**LEGEND (ALL CHANGES TO ALL LEVELS)**

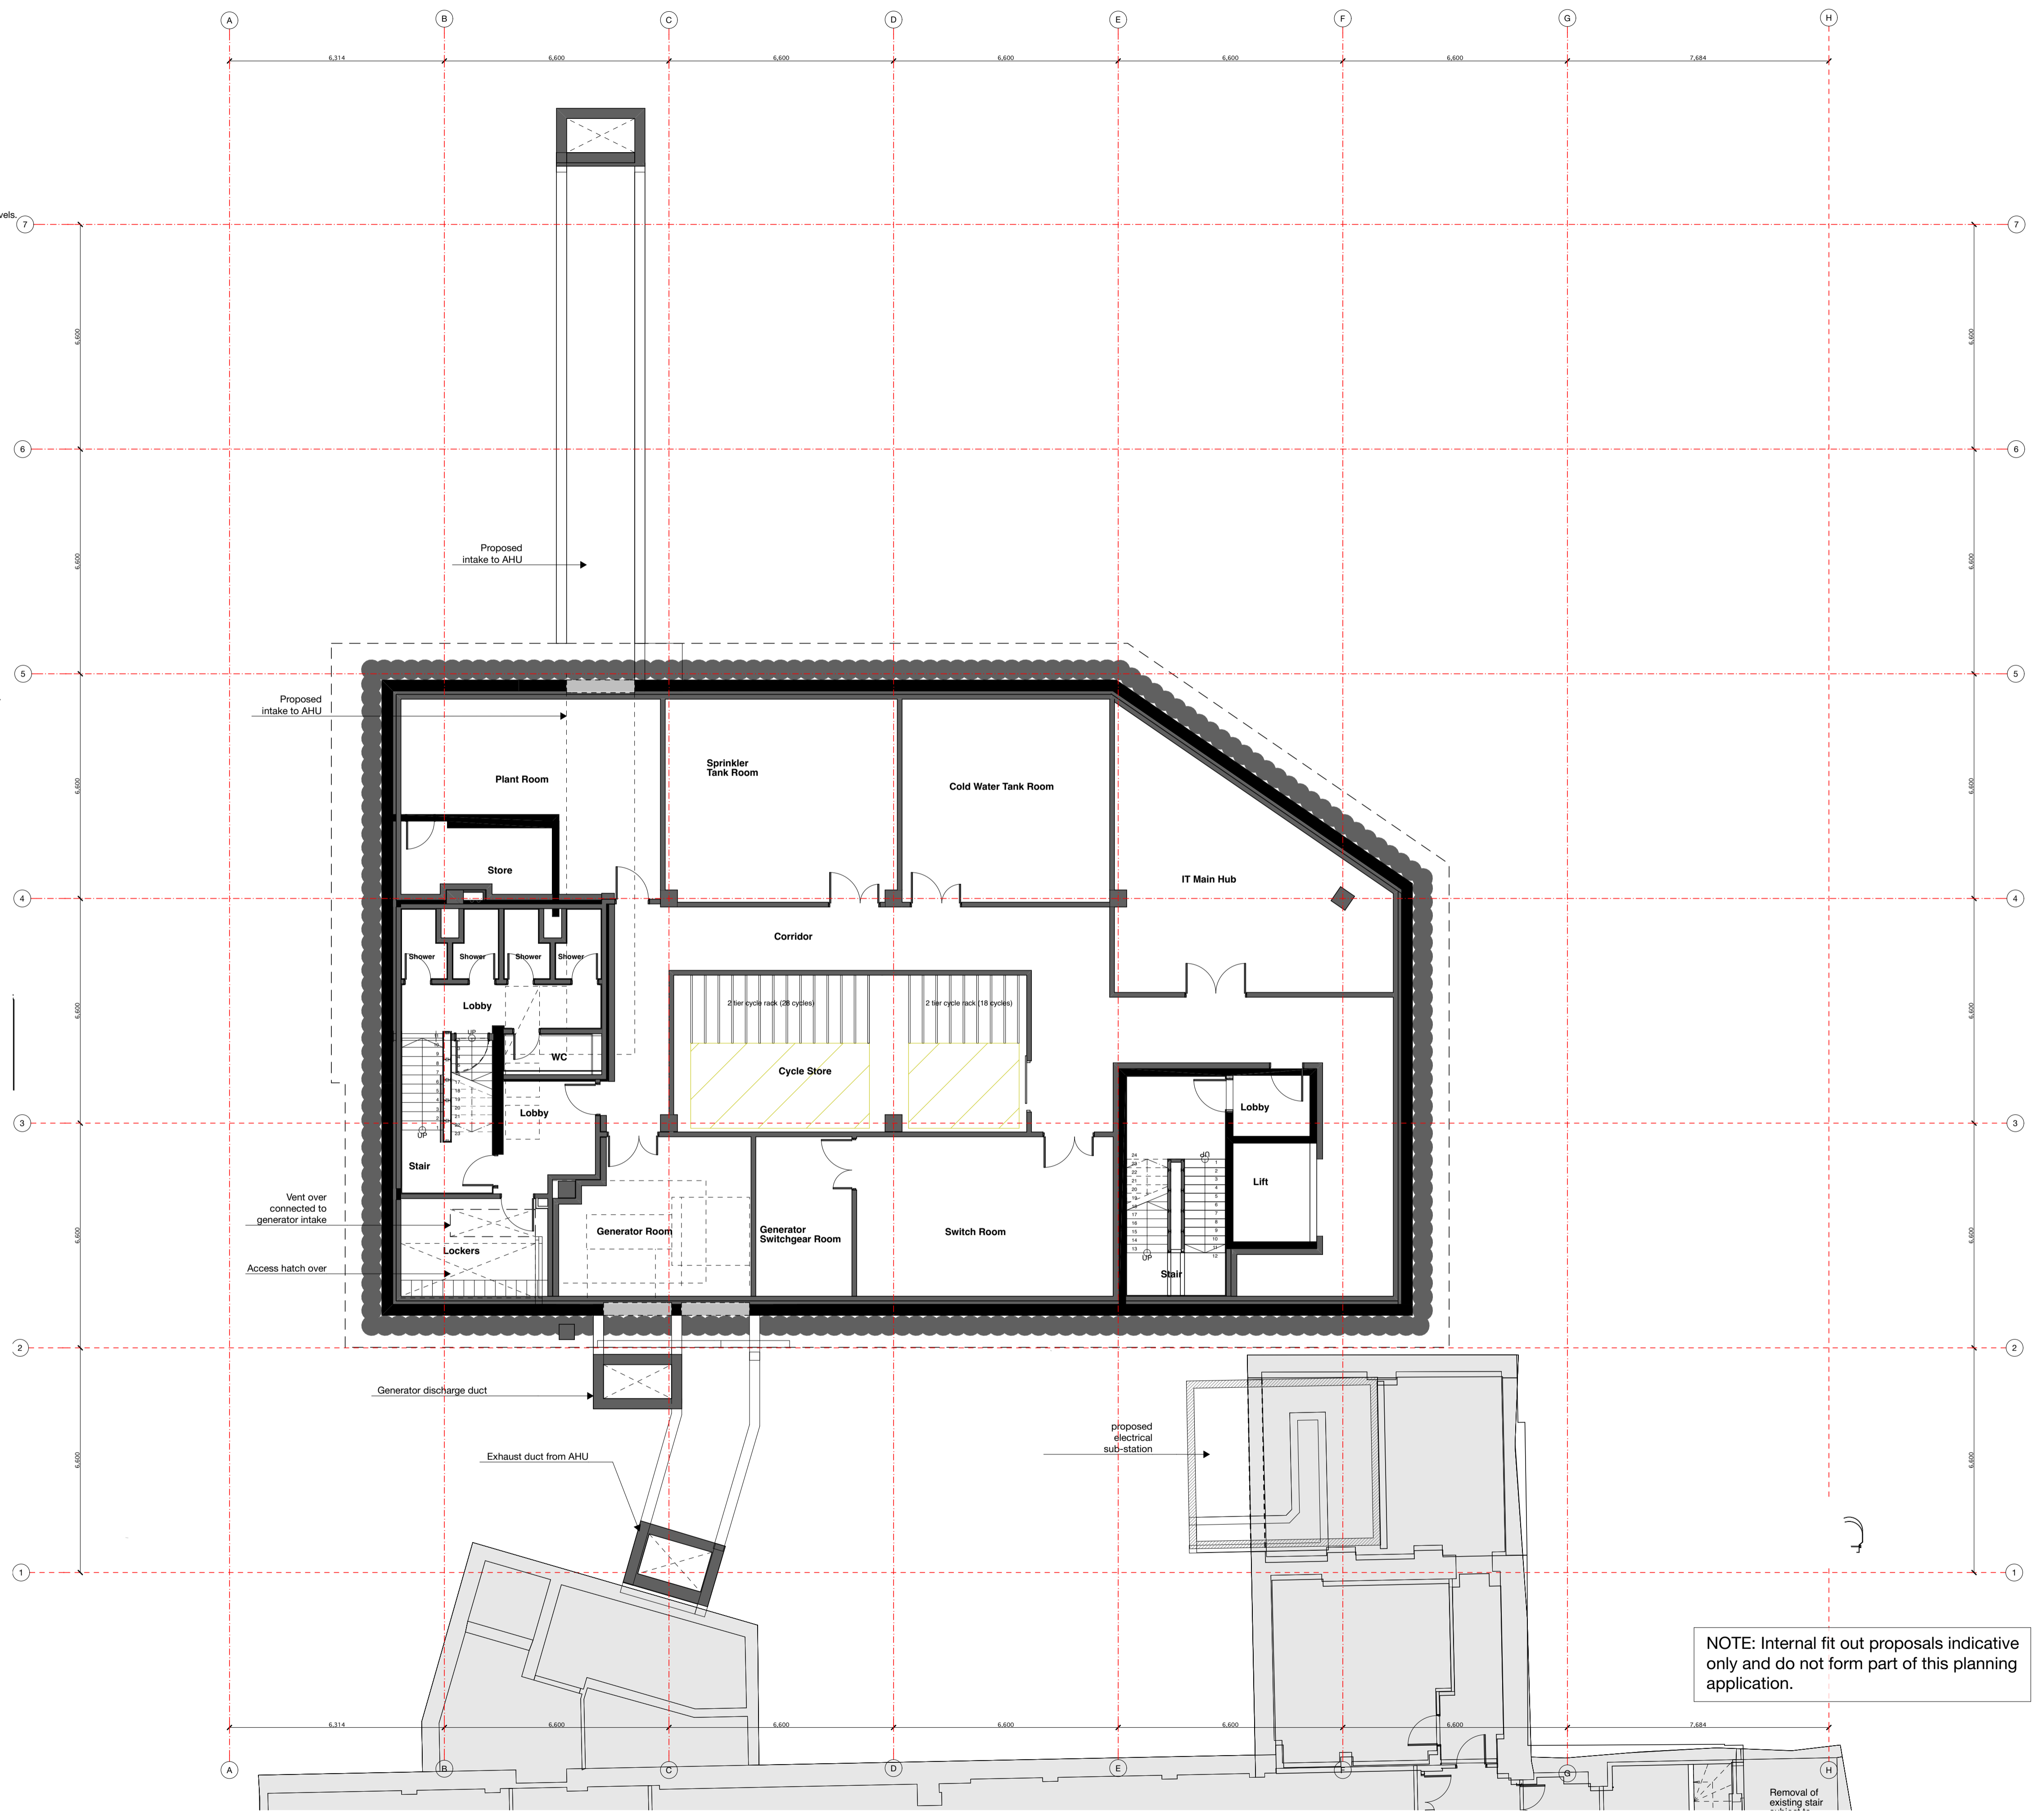
- 01 Stair 2 omitted, and glazed entrance enclosure enlarged
- 02 Window added
- 03 New steps to base of external spiral stair
- 04 Stair 3 roof and gable end arrangement revised.

- 05 Level 3 accommodation mansarded
- 06 Roof light size, height and position adjusted, and smoke vents added.
- 07 Louvres omitted.
- 08 Roof light size, height and position adjusted.

- 09 External ramp adjusted, and railings added.
- 10 West stair core glazing fenestration adjusted to suit amended stair landing levels.
- 11 External paving levels in courtyard raised to achieve required paving falls.

- 12 Low brick plinth added to base of external walls to TP2.
- 13 Brick plinth added to base of existing buildings within courtyard.
- 14 New steps and landing outside room G1.

- 15 Bin store enlarged and repositioned.
- 16 Gallery passageway to TP2: finishes revised.
- 17 Gallery passageway: entrance gates design revised.
- 18 Window on north elevation of TP2 reduced in length.

- 19 Revised turn-table size and position
- 20 Entrance ramp gradient and levels adjusted.
- 21 External levels adjusted
- 22 TP1 west door ramp omitted
- 23 Fall restraint added

- 24 Gates removed
- 25 Maintenance access door added
- 26 Parapet revised
- 27 Roof/wall shape adjusted
- 28 TP1 reception relocated
- 29 Revised door design

- 30 Modifications to windows, doors and facades facing into courtyard.
- 31 Gate details revised
- 32 Revised proposal for bike storage replacing existing bike racks in Dairy shed.

- 33 Gate retained and modified
- 34 Bike canopy detail revised (typical condition highlighted)
- 35 Sub-station doors revised
- 36 Steps adjusted
- 37 Cladding changed to brass finish

- 38 Wall mounted planters revised (typical condition highlighted)
- 39 Steel posts added to boundary wall (typical condition highlighted)
- 40 Height of glazed entrance roof increased to suit required pitch.

- 41 Glazed entrance roof and canopy revised
- 42 New roof guarding to existing flat roof
- 43 Screening fins and cladding added
- 44 Louvres added
- 45 Ramp omitted

- 46 Door removed and infilled
- 47 Access hatch adjusted.
- 48 Depth of green/blue roof build-up adjusted.
- 49 Blue roof incorporated into green roof and gravel margins added.

- 50 Cladding build-up adjusted
- 51 Orientation of brass seams adjusted
- 52 Roof gutters revised.
- 53 Means of escape revisited and exit door added to TP1

- 54 Spiral staircase landings added at each floor
- 55 Door modified
- 56 Basement louvres to external metal staircase landings
- 57 Revised proposal for mean of escape in TP1

- 58 Revised proposal for window and door
- 59 Revised proposal for door to be left as current
- 60 Gate to be removed
- 61 Capping width adjusted and roof planters shown indicatively.

- 62 Door to be replaced
- 63 Revised proposal for the entrance
- 64 Gates and Entrance door in TP1 to be replaced
- 65 Existing stair to be demolished
- 67 Existing window and door to be replaced

- 68 New reconfiguration for new spiral stair and WC
- 69 Staircase partially demolished
- 70 Level adjusted
- 71 Lift pit adjusted
- 72 Level updated
- 73 Red line extended to include South Crescent Mews

- 74 Red line extended to include new ramp and frontage
- 75 Ladder added
- 76 Works to Mews paving/kerbs added
- 77 Minor adjustment to ridge, and eaves line, (not affecting ridge level noted on consented drawings).
